STAFF REPORT August 21, 2024
Historic Preservation Commission

201 LINDEN STREET (LINDEN HOTEL) – DESIGN REVIEW (CONTINUED FROM JULY 17, 2024)

PROJECT DESCRIPTION: Alterations to the Linden Hotel at 201 Linden Street to include complete replacement of the historic windows on the second and third floors of the building.

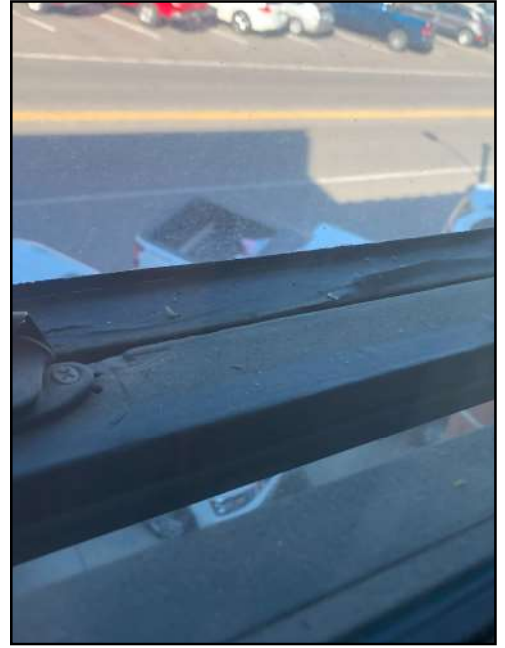
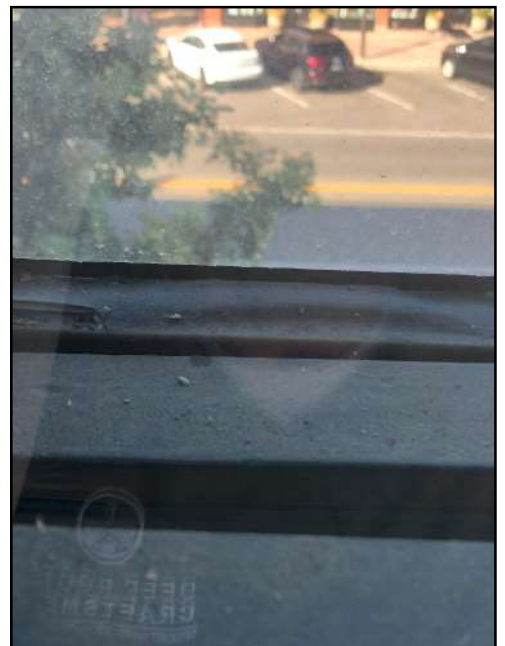
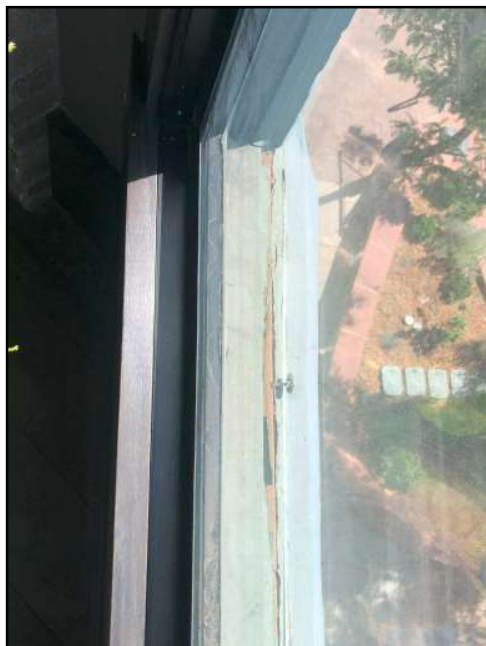
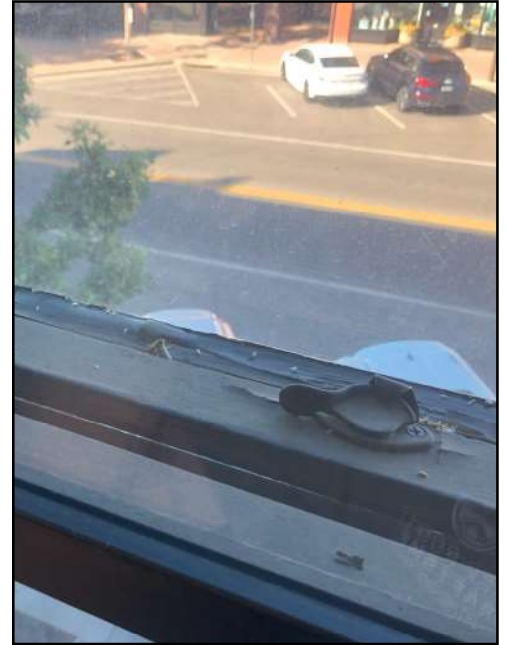
LARGE GAPS BETWEEN PARTING STOP AND MEETING RAILS

SASHES HEAVILY MODIFIED FOR SPRING BALANCES

CHIPPING AT MEETING RAIL WHERE ROUTED FOR WEATHERSTRIPPING

PAINT FAILURE

MISALIGNMENT AT MEETING RAILS

STRUCTURAL FAILURE AT MEETING RAIL

Image 15: Evidence of overpainting. A section of paint was removed to show where the paint should have ended. The area between the arrow points is over painted

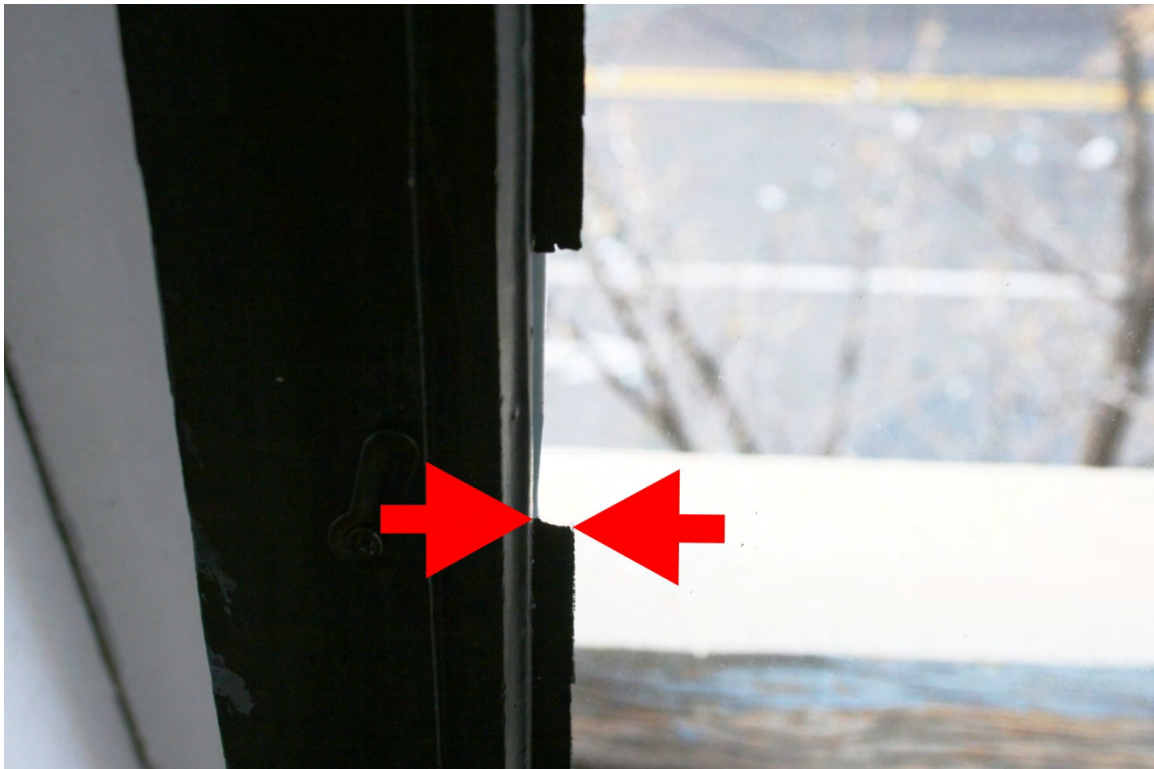
Image 14: Note how the new glazing compound does not come up to the edge of the bed and has a ragged edge

Image 1: Paint failure, lower sash

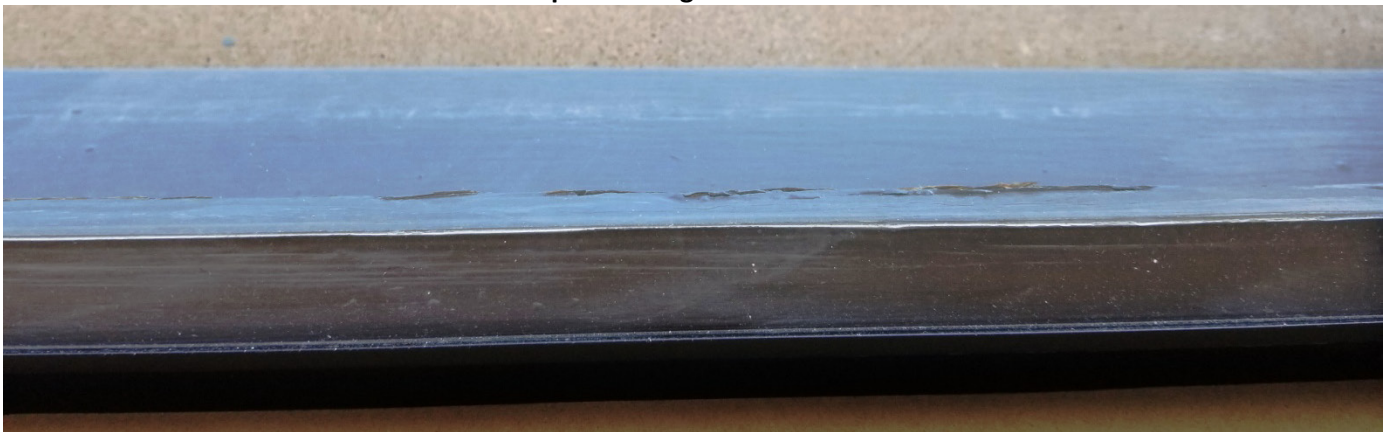
4. All of the original paint was not removed from the sash, potentially hiding additional defects
 - The proposed corrective measure was to strip each sash to bare wood, evaluate the underlying conditions, make repairs as necessary, and repaint
 - **The sash of the mock-up window appeared to have been stripped and repainted. However, some paint failure was observed on the lip of the glazing bed of the lower sash and on the blind stop. The glazing bed paint failure may be due to abrasion during install, but the blind stop paint failure appears to be related to excessive moisture. Recommendation is to review the caulking around the perimeter to ensure that no moisture is penetrating into the wood.**

Image 2: Paint failure, blind stop

Image 15: Evidence of overpainting. A section of paint was removed to show where the paint should have ended. The area between the arrow points is over painted

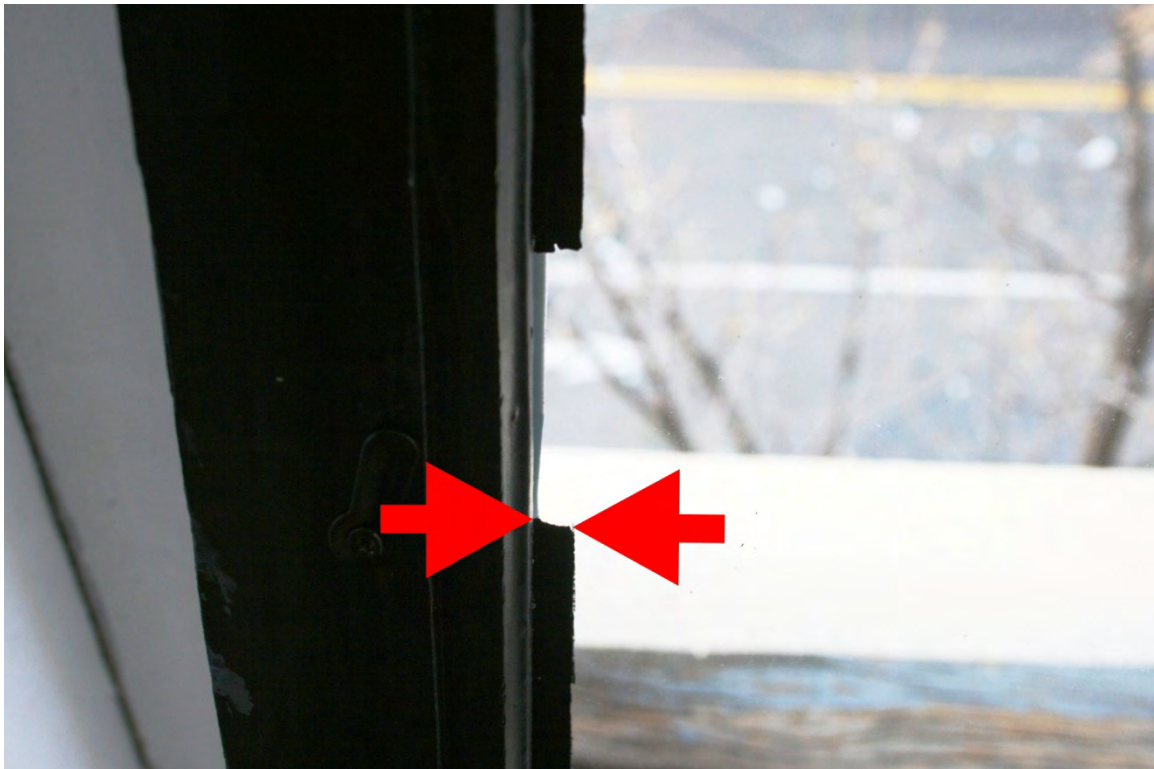
Image 14: Note how the new glazing compound does not come up to the edge of the bed and has a ragged edge
